WATER RESOURCES DEPARTMENT

TO: Application G- 17497
FROM: GW: GERALD H. GRONDA
(Reviewer's Name)
SUBJECT: Scenic Waterway Interference Evaluation

PUBLIC INTEREST REVIEW FOR GROUND WATER APPLICATIONS

SUBJECT: Application G-17497 Supersedes review of _____
Date of Review(s)

STATE OF OREGON
 WATER SUPPLY WELL REPORT
 (as required by ORS 537.765 & OAR 690-205-0210)

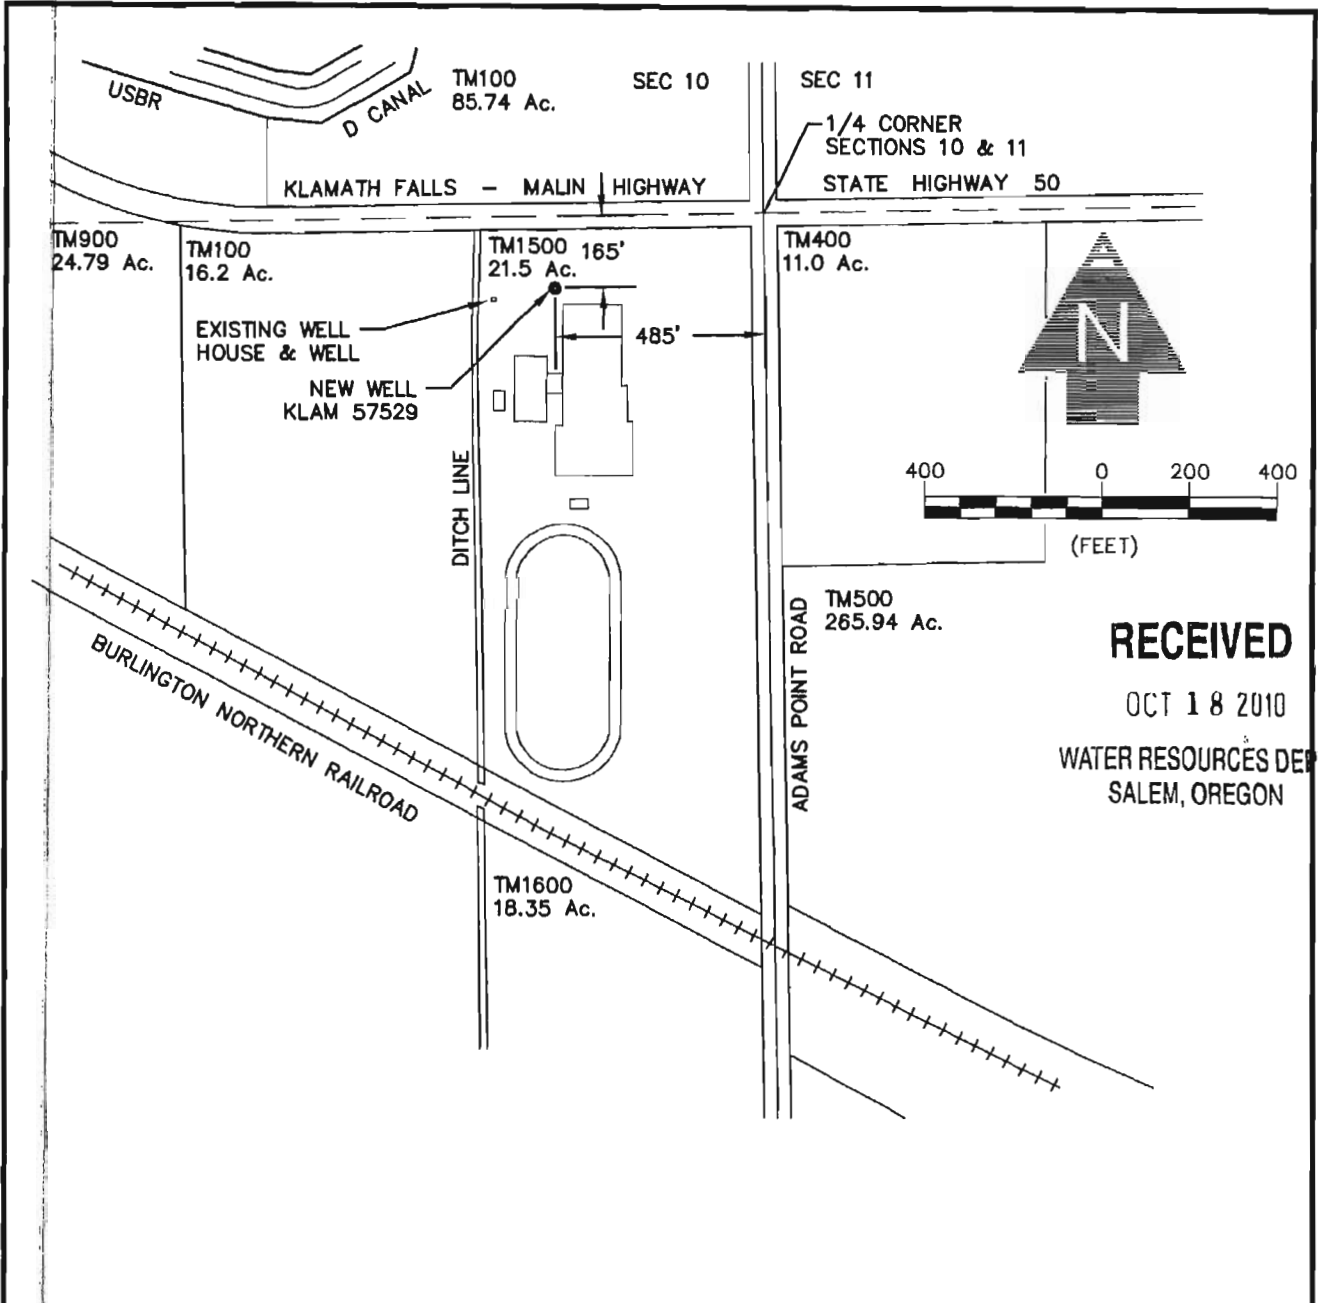
Owner well 1 (KLAM 57529) is currently used as an exempt well supplying water to the school up to 15,000 gallons per day. This application proposes to additionally use the well for groundwater production for heat exchange. Based on the water well report, the well obtains groundwater from the predominant basalt unit below the basin-fill sediments.

The groundwater elevation in the table above is based on state observation well data. It is not appropriate to use the static water level data on the water well report (well log) for the proposed production well (KLAM 57529), because that measurement occurred during the summer of 2010, the time of greatest drought related groundwater pumping and greatest seasonal groundwater level drawdown.

The well meets the recommended permit conditions for well construction and groundwater production.

KLAM 53269
State Observation Well N.A.
T41S/R11E-sec 10 aad
Merrill-Malin (Adams Point)

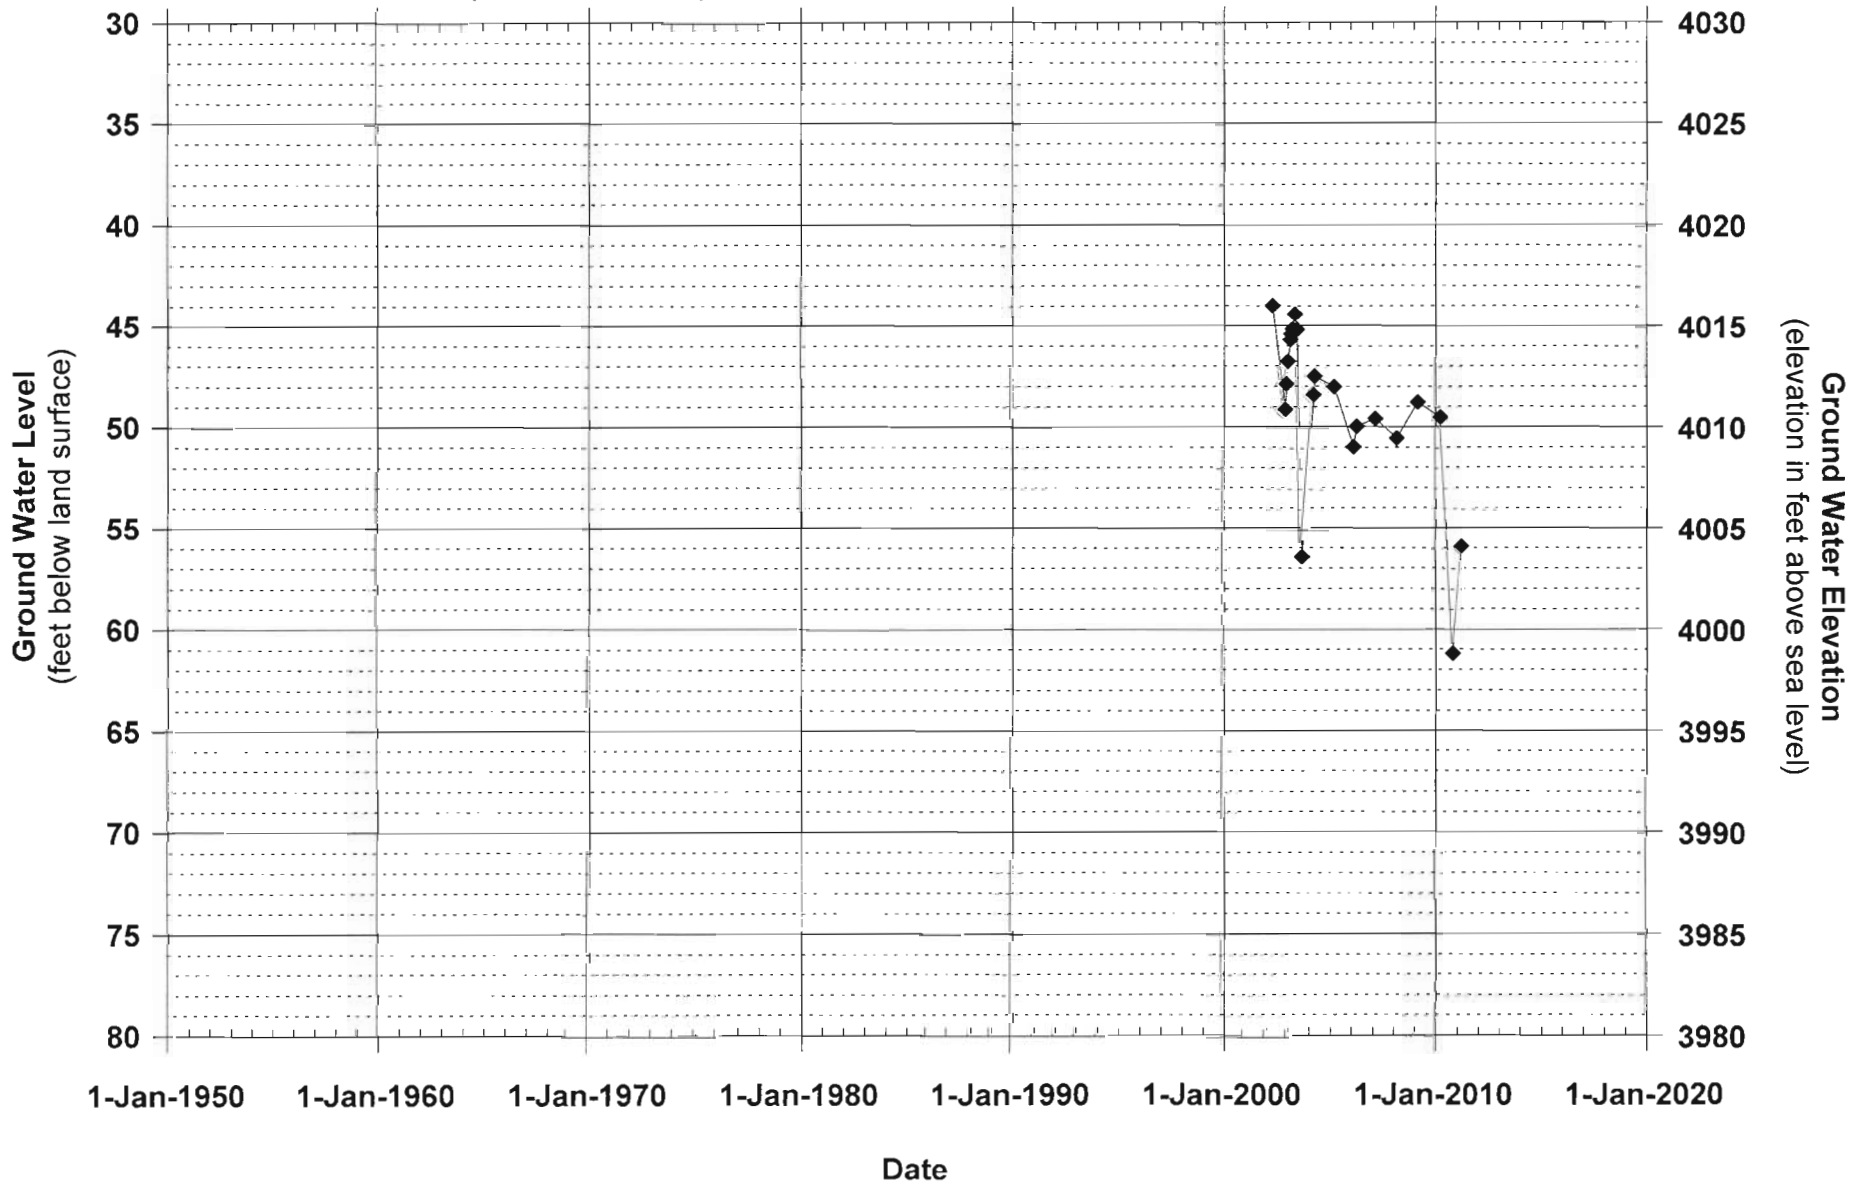
7N, the measurement condition modified (change part "A" from three to "one or more feet", merge "B" and "C" to read "Annual water-level measurements reveal a water-level decline of 5 or more feet:", and change part "D" from 25 to "10 or more feet", and add a part "E" to read "OWRD groundwater section staff approved static ground water level measurements at well KLAM 53269 (Loren Kandra) near Adams Point is below 55 feet below land surface", and insert the following to the last paragraph after "no action is necessary because...": insert "...the use is not contributing to the decline or contributing to the groundwater level being below 55 feet below land surface at well KLAM 53269 or because...").

7N, the measurement condition modified (change part "A" from three to "one or more feet", merge "B" and "C" to read "Annual water-level measurements reveal a water-level decline of 5 or more feet", and change part "D" from 25 to "10 or more feet", and add a part "E" to read "OWRD groundwater section staff approved static ground water level measurements at well KLAM 53269 (Loren Kandra) near Adams Point is below 55 feet below land surface", and insert the following to the last paragraph after "no action is necessary because...": insert "...the use is not contributing to the decline or contributing to the groundwater level being below 55 feet below land surface at well KLAM 53269 or because...").

**KLAM 14914
State Observation Well 293
T41S/R09E-sec 12 aab
South Klamath Hills Vicinity**

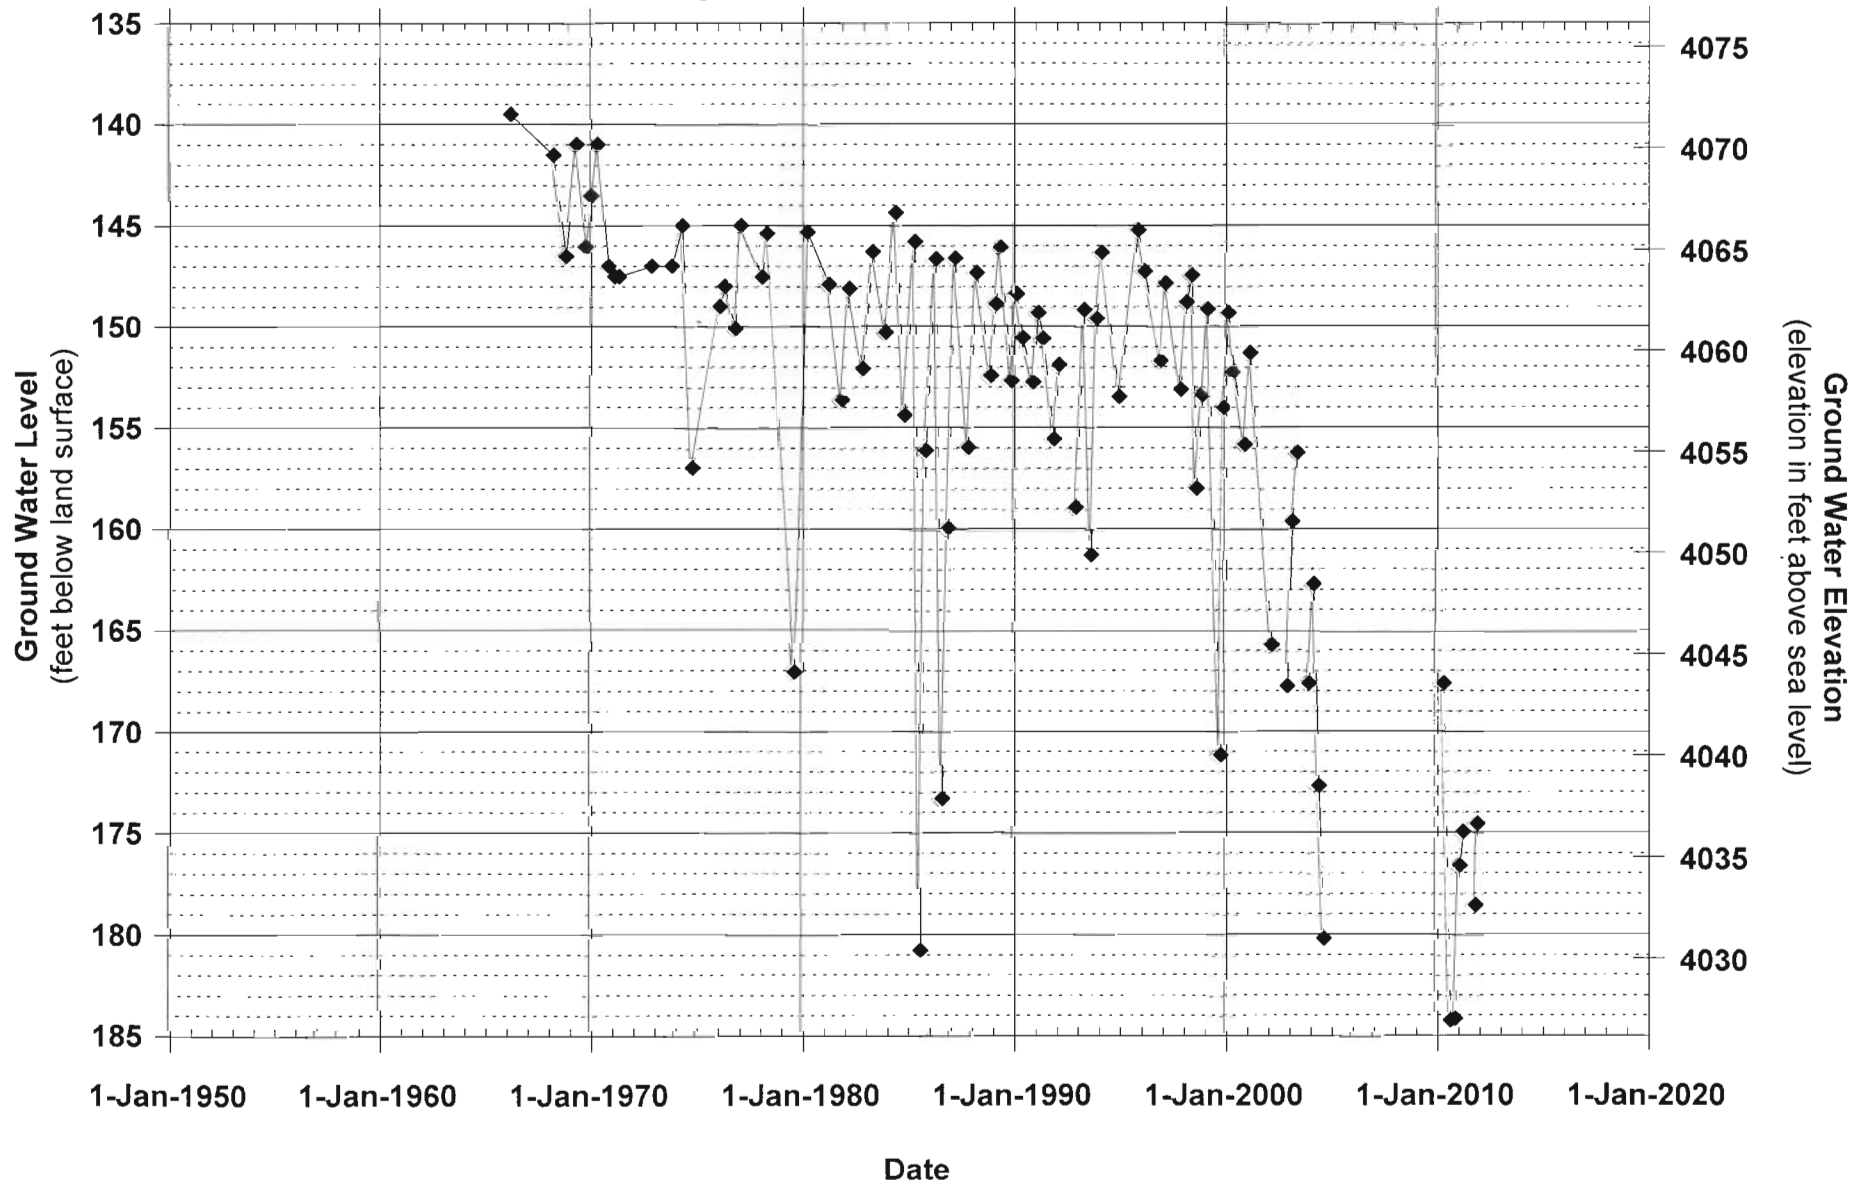
Long term state observation well groundwater level data related to state observation wells 293 (KLAM 14914), 334 (KLAM 14764), and 1358 (KLAM 52194) show climatic influences. Additionally, these and the City of Merrill well (KLAM 14959) and California well 48N04E16M001M (TID well #3) and well 48N03E14M001M clearly show a significant decline that began after the 1990s when comparing annual peak water levels. The hydrograph for each well is attached. The total decline in the area ranges from 15 to 30 feet. A map showing the 2010 seasonal decline and a map showing the total decline from spring 2001 to spring 2011 are attached. These are consistent with and update what was reported by Gannett and others (2007) and the USGS (2005). The declines are greater than typically observed during drought periods. They appear related to the USBOR Klamath Project Water Bank. Any additional (net increase) groundwater use in the Merrill-Malin area risks increasing the decline rate. This application does not propose any additional (net increase) groundwater use.
